Grip Cap Screw NSN?

SPRING PIN TOO BIG? *DO THIS*

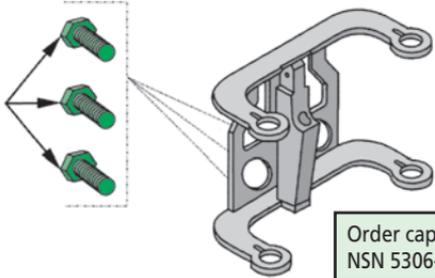
When I try to order the cap screws for the MK 19 machine gun's control grip assembly (Item 10 in Fig 8 of TM 9-1010-230-23&P), the NSN doesn't show up on FED LOG. What is the correct NSN?

CHIEF R.N., THE *CORRECT* NSN IS 5306-01-564-3587 AND ITS NEW PN IS B1821BHO31FO44L.

THIS WILL BE CORRECTED IN THE NEXT REVISION TO THE TM.

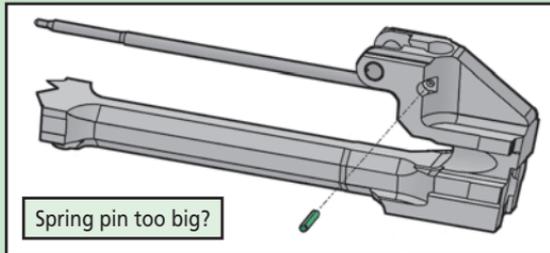
When you order the spring pin that holds the M240 machine gun's firing pin in the operating rod, you may get one that's too big to fit. (The pin, NSN 5315-01-033-8873, is Item 4 in WP 0037-001 in TM 9-1005-313-23&P.)

If that happens, substitute the spring pin, NSN 5315-01-033-3889, that's Item 5 in WP 0044 00-3. Cut the pin in half so that you have two pins 16mm (0.63 inch) long. File a chamfer around the end of the pin. You now can install the spring pin in the op rod.
